Highgate CAAC objection to [HGY/2026/0550](#) 12 Parklands, London N6 5FE

Loft conversion including extension to hipped roof and erection of rear dormer, installation of flat roof to existing rear dormer, and replacement of front and rear fenestration.

Detail from the rear elevation drawing in document "PAR_Proposed set (6 pages).pdf"

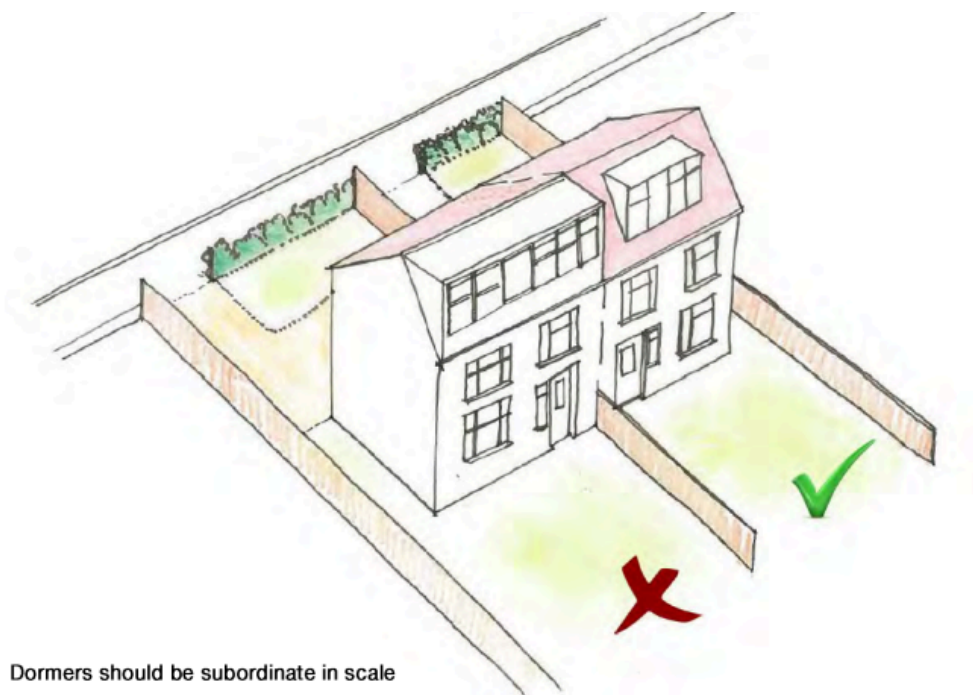
The larger dormer is not subordinate in scale, does not sit comfortably within the roof form, and is not set in from the ridge and sides by 1m - see illustration on page 167 of the HCA CAAMP:

Also contrary to para 12.2.13, the two proposed flat roofed dormers do not compliment the roof form of the original house. They will also destroy the consistency with its neighbours, and set a precedent for other incongruous changes.
